## PRODUCT BULLETIN

**PB NO. 102**  
**REV. 0**

**SUBJECT: Camshaft Lobe Wear**  
**Superior 510 & 825 (Inline-Vee) Series Engines**

**PROBLEM** Premature Camshaft Lobe Wear Caused by  
Inadequate Pin to Roller Lubrication

*CAM FOLLOWER ASSEMBLY*  
*— FOR MODEL 510 SUPERIOR ENGINES —*

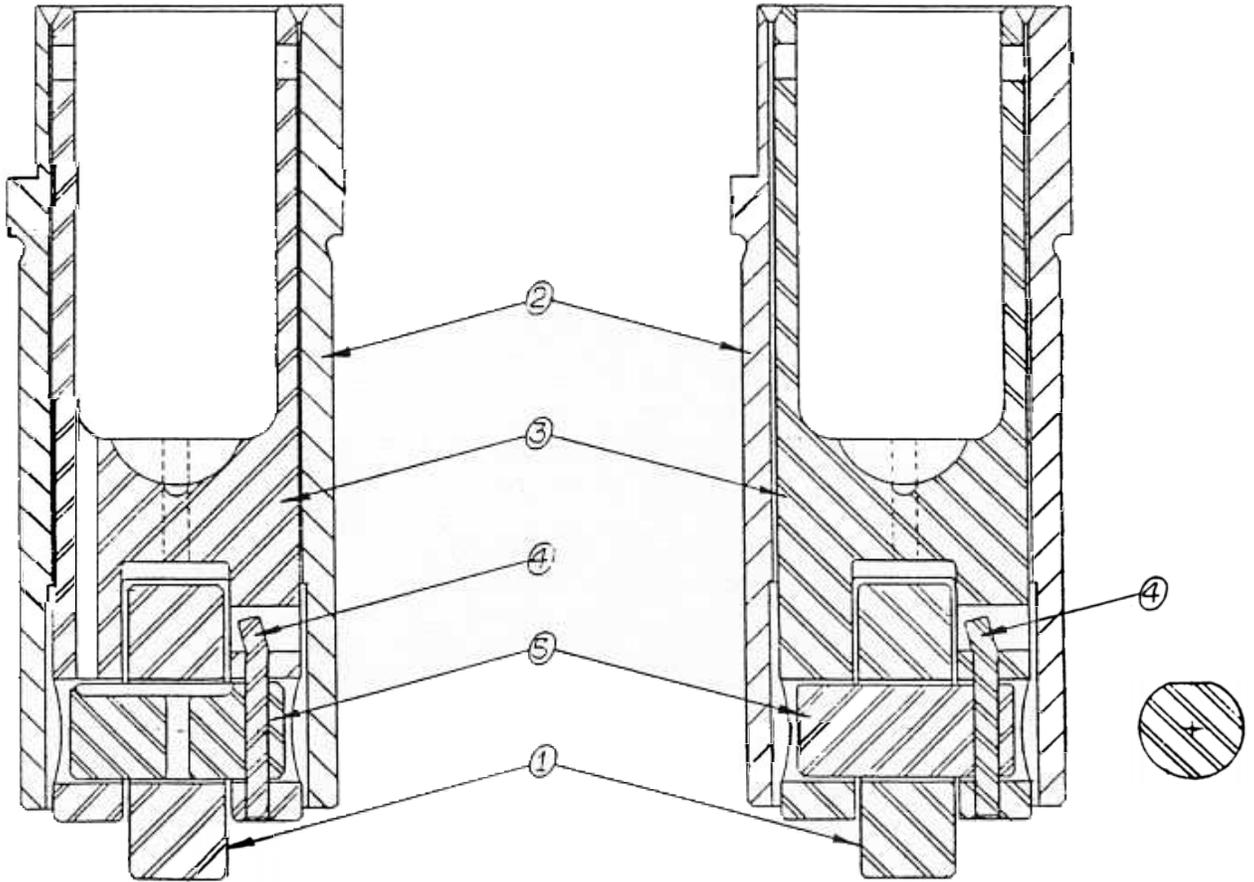
III. Solution: The solution to the above problems a new **PowerParts**<sup>®</sup> cam follower assembly with the state of the art materials and a design which increases the roller to pin lubrication over 10 times. The attached cross sections, compares the OEM and **PowerParts**<sup>®</sup> assemblies and indicates the design changes which result in proper pin to roller lubrication.

4. The new **PowerParts**<sup>®</sup> design prelubes the roller-pin area by filling the pin top groove and through hole to the load side of the pin.
5. All standard available designs showed roller to pin galling after as low as 1-1/2 hours of operation in splash environment. No roller to pin galling was present in the new **PowerParts**<sup>®</sup> design in one (1) week continuous run with zero splash lubrication.
